**TOWN OF WINTER PARK
PLANNING COMMISSION**
Tuesday, February 13, 2024 8:00 AM

RE Minor Site Plan – Building A, Village Center Condominiums of Winter Park
– 78491 Highway 40 (PLN24-001)

Address: Building A, 78491 Highway 40

SOUTH ELEVATION

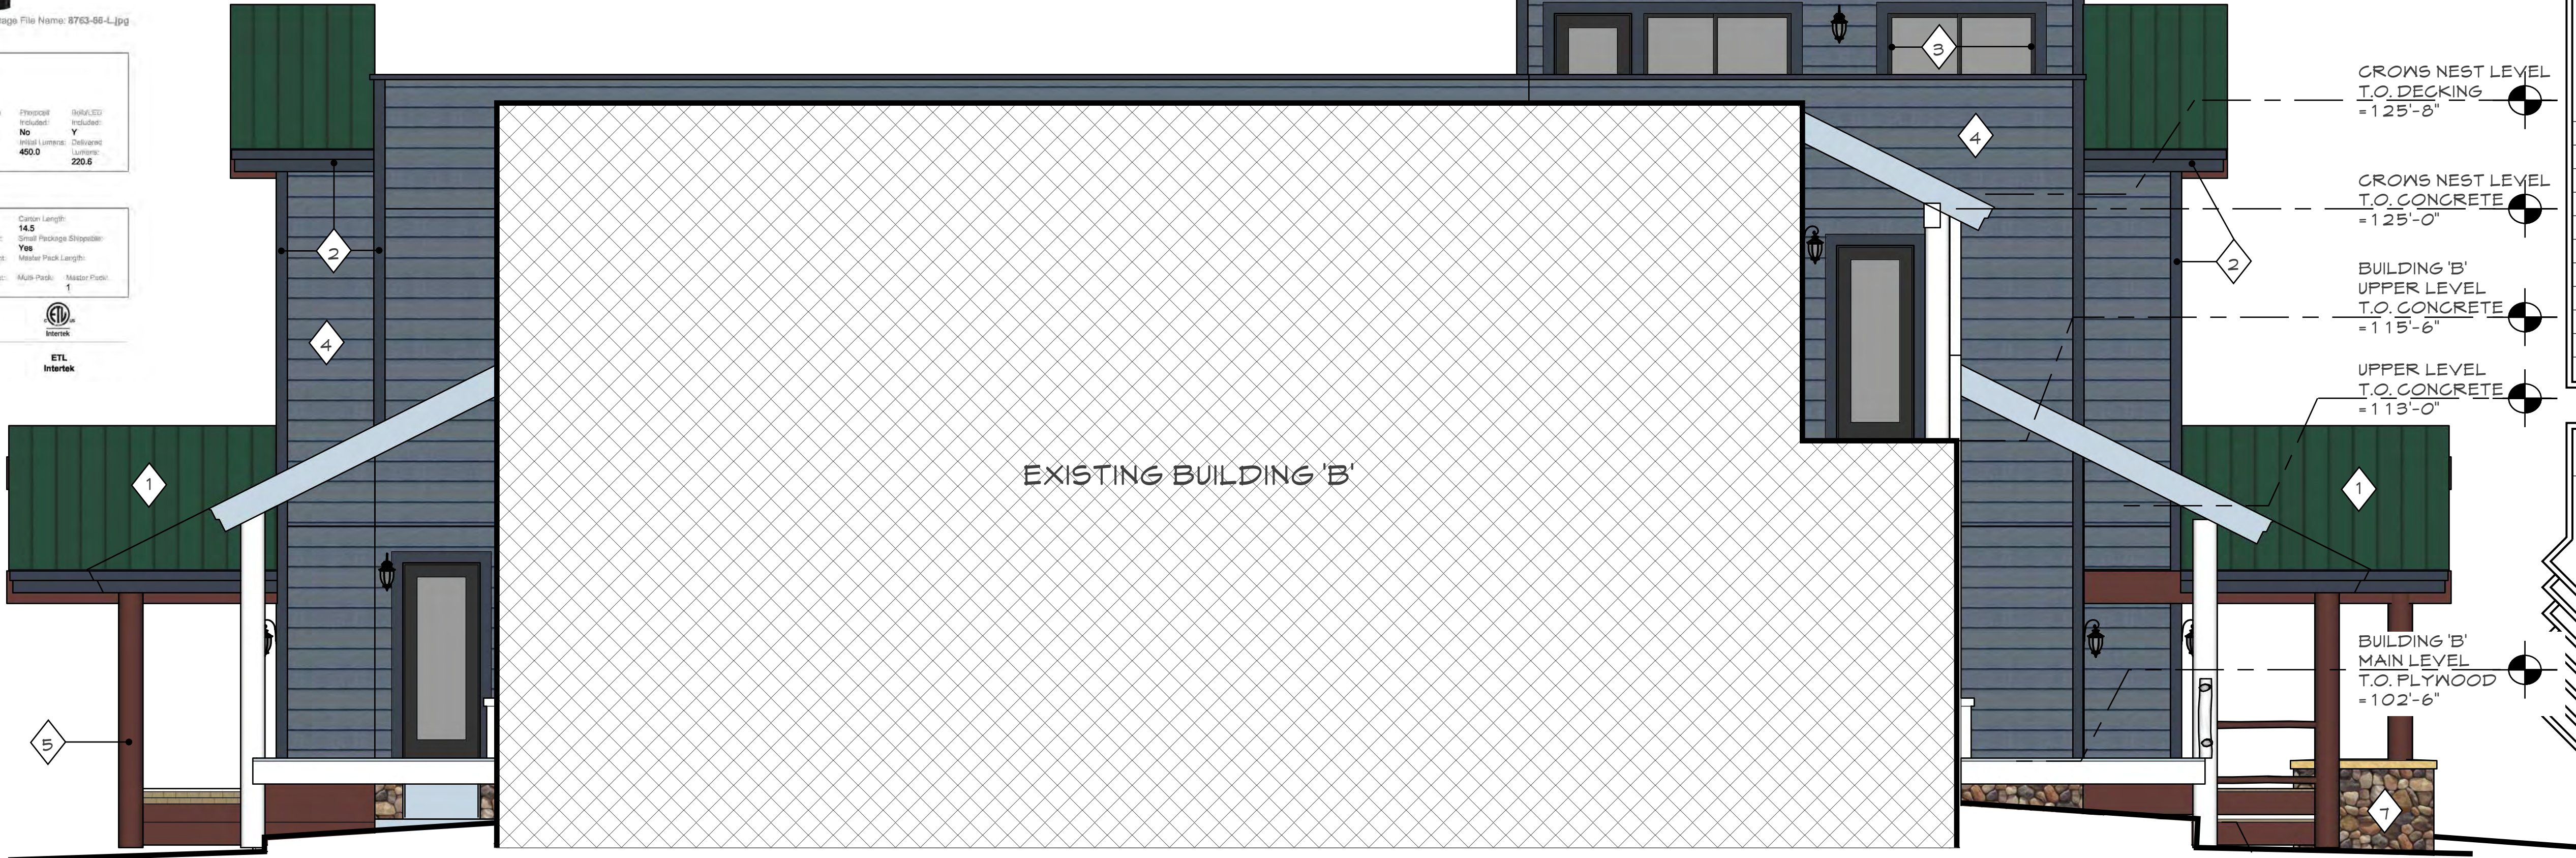
Partially satisfactory. Materials are not indicated for doors. The proposed materials will match those on the existing buildings within Village Center Condos.

Unsatisfactory. One (1) fixture is proposed and it contains the International Dark Sky Association (IDA) approval stamp as required (UDC, § 3-K-3(A)(1)). The BUG Rating has not been indicated; it cannot exceed B1, U0, and G1. Both building and parking fixtures shall not exceed the height of the eave line, parapet wall, or twenty-one feet (21'), whichever is less; heights are not indicated.

Satisfactory. Staff believes the building complies with the 2021 Update to the Design Guidelines. The building shares the same materials and colors as most of the complex. Building C's siding (the Noble Buck) is painted a different color, beige.

- Applicant shall indicate materials and colors for doors.

- Applicant shall indicate proposed height for all fixtures.
- Applicant shall submit manufacturer spec sheets for all existing fixtures so staff can determine if fixtures conform with Article 3.K, Outdoor Lighting. If they do not, then Applicant

SITE / LANDSCAPE PLAN

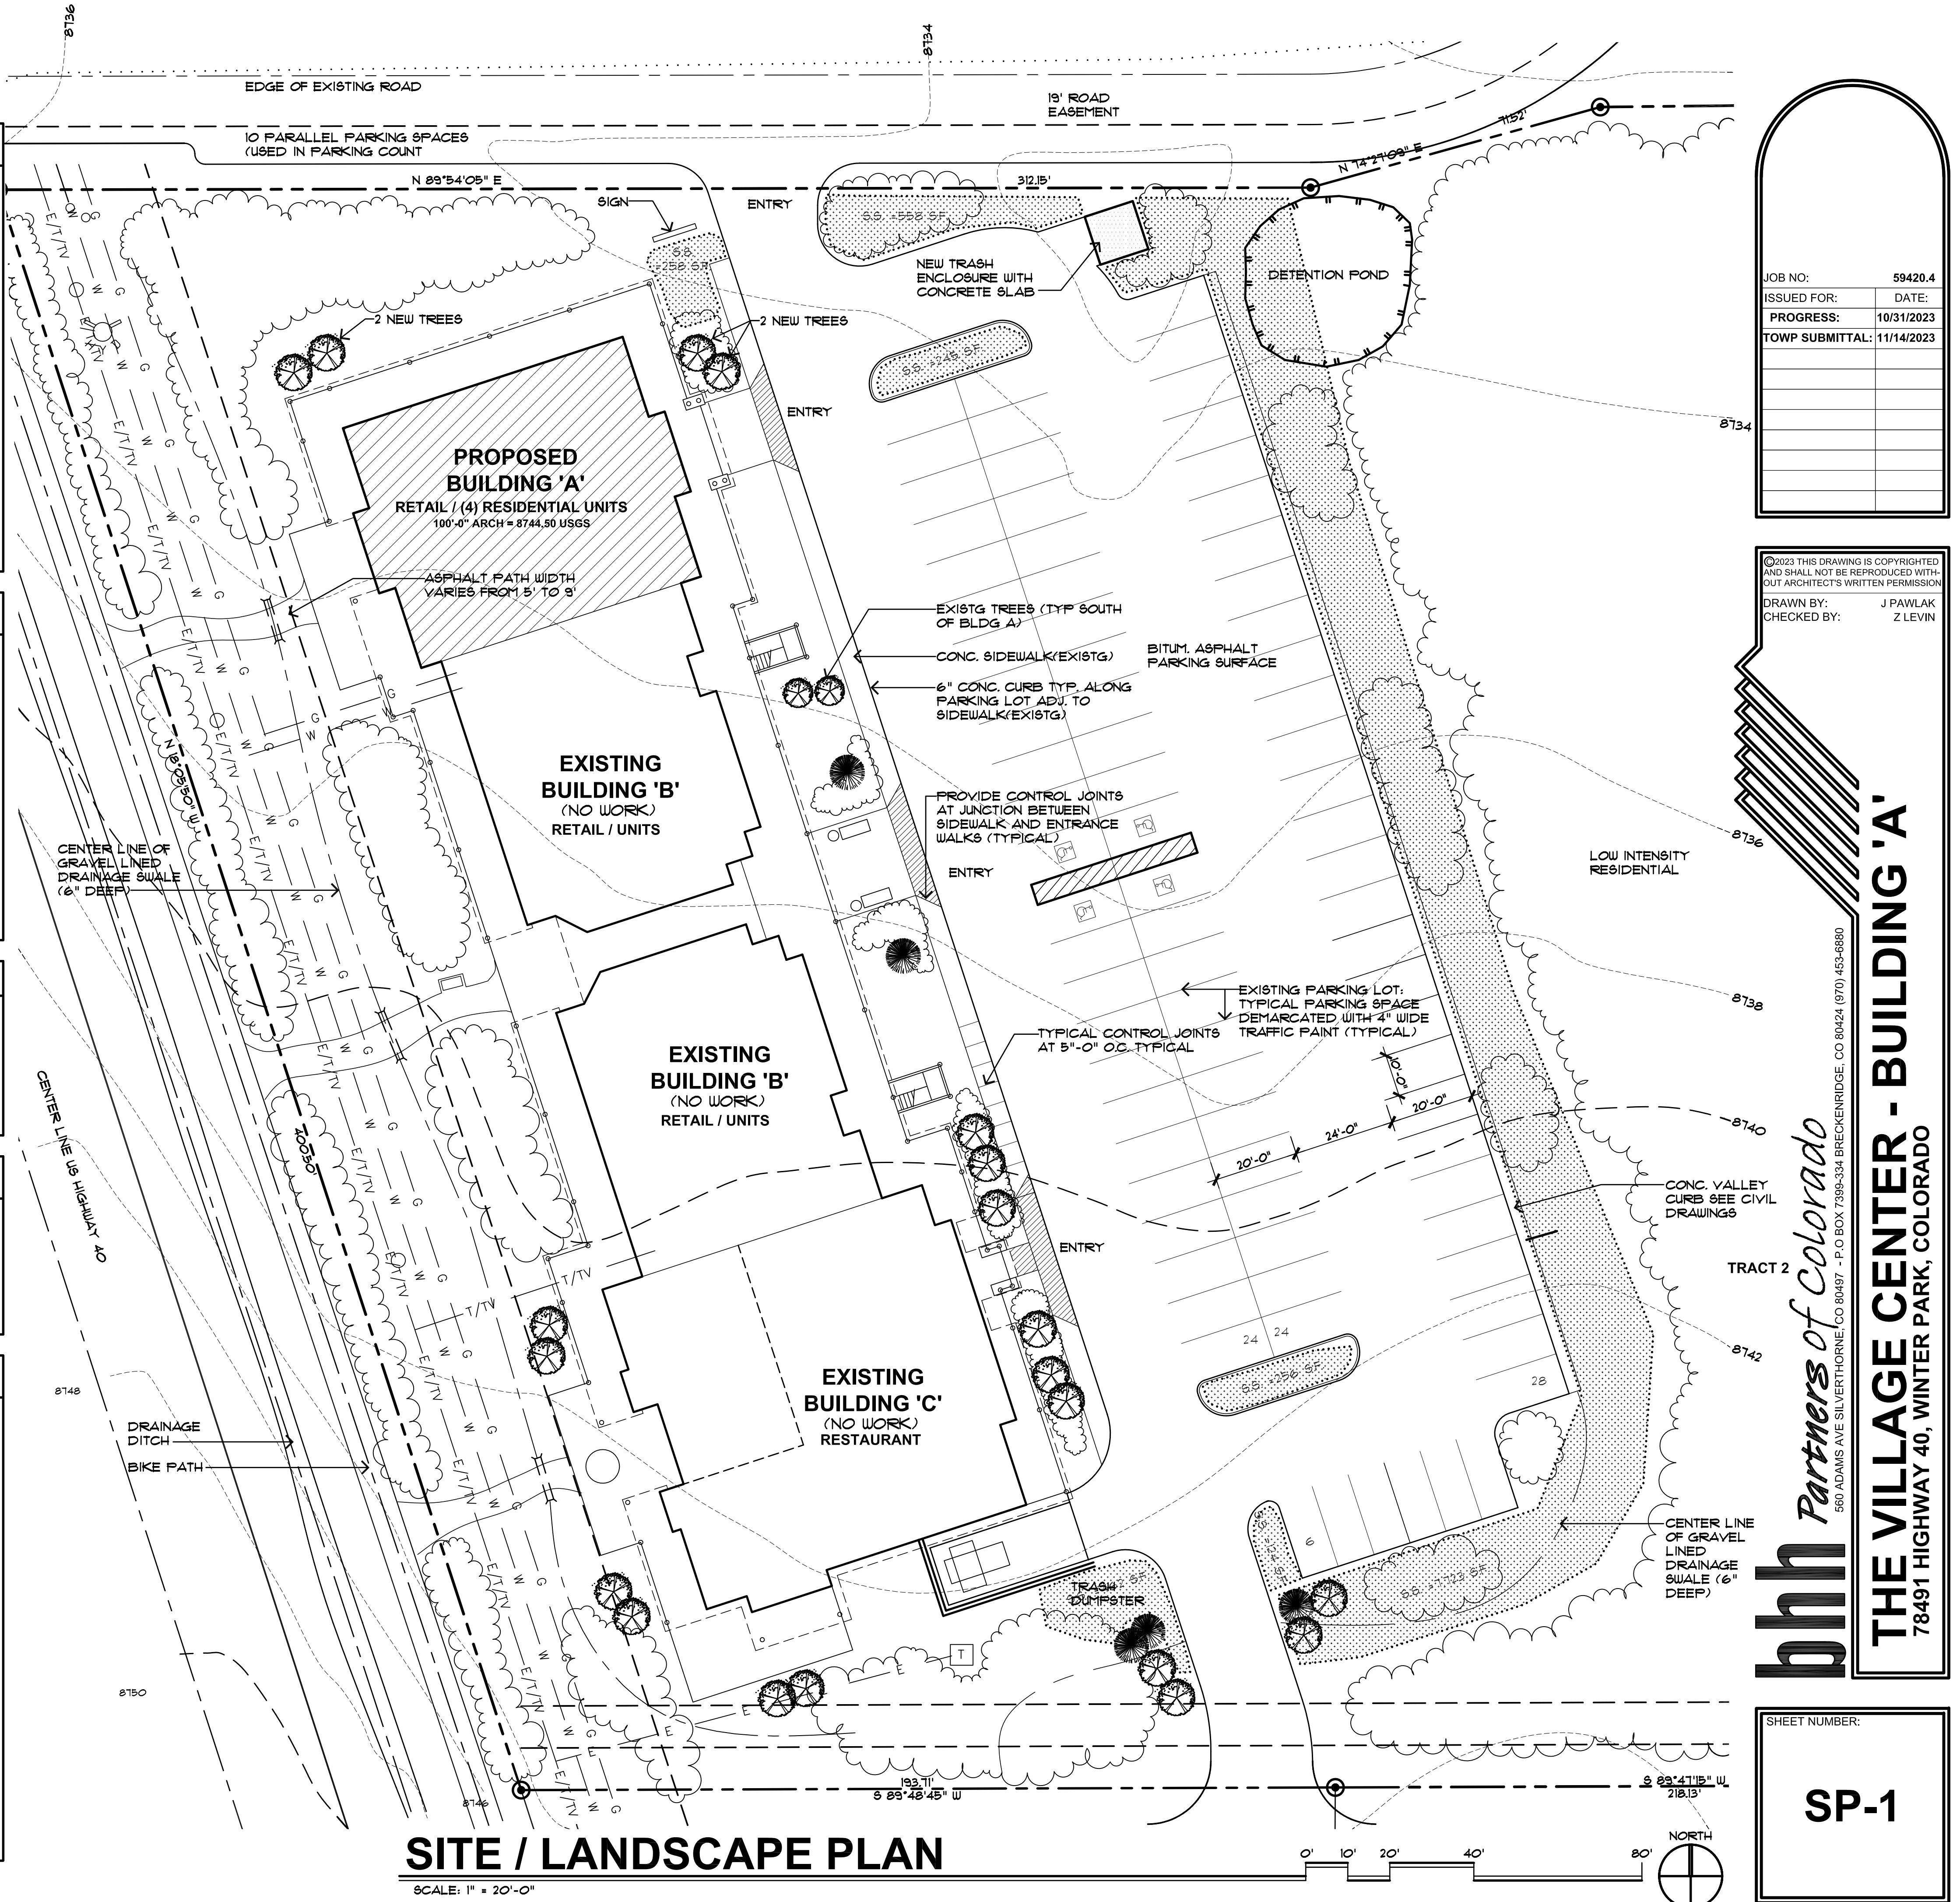
Partially satisfactory. The Property contains existing landscaping that meets the bufferyard requirements in § 3-I-5, Bufferyards. In the immediate surroundings of the proposed building, four (4) new trees are proposed: two on the north side and two on the east side. The required bufferyard types for the Property are as follows:

The Limit of Disturbance is not indicated as required. Applicant notes on the Landscaping Plan dated 11/28/2023 (note 2) that they will attempt to keep all existing trees where possible.

Satisfactory. UDC, § 3-H-5, Parking Design Standards requires that a minimum of 25% of all driving surfaces, including gravel shoulders, parking areas, and pedestrian walkways is designated for snow storage. These areas comprise 34,769 sqft, meaning that at least 8,692 sqft shall be provided. 27% is provided (9,626 sqft).

- Applicant shall indicate Limit of Disturbance on the Landscaping Plan and Construction Plans.
- No site clearing shall be permitted until the Building Division has verified the Pre-Disturbance Checklist has been implemented on the site.
- Any disturbed areas on the site shall be revegetated with the seed mix recommended by the Grand County Natural Resource Conservation Service, which mix composition is described in Section 7.4 of the Standards and Specifications for Design and Construction.
